Project
 PROPOSED DEVELOPMENT AT
 BALTONSBOROUGH
 GLASTONBURY
 SOMERSET

Drawing Title
 Plots 42-45 Proposed Plans

DWG No. 4424-42-45-P01

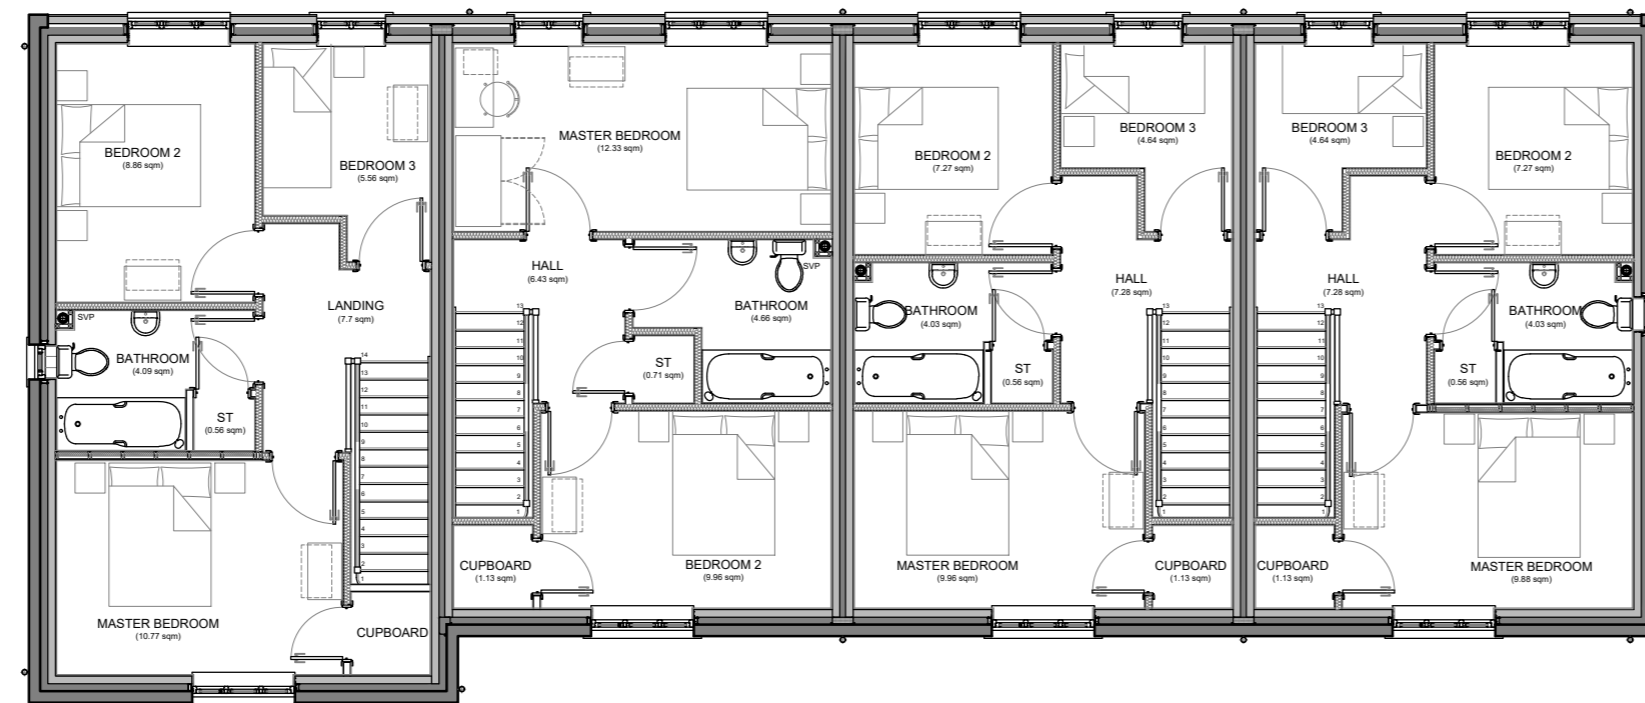
- Stone plinth omitted.
- Plots 42-44 changed to render.
- Rear elevation changed from render to brick.
- Front elevation door sidelights omitted.
- Front elevation porch sizes scaled down.
- Rear elevation ground floor french doors & window omitted with single pair of bifold doors.
- Dormer windows to rear elevation omitted and replaced with windows in external wall.
- Dormers above windows on front elevation omitted.
- Velux windows to rear elevation omitted and replaced with windows in external wall.
- Eaves height raised 450mm.
- Chimneys omitted.
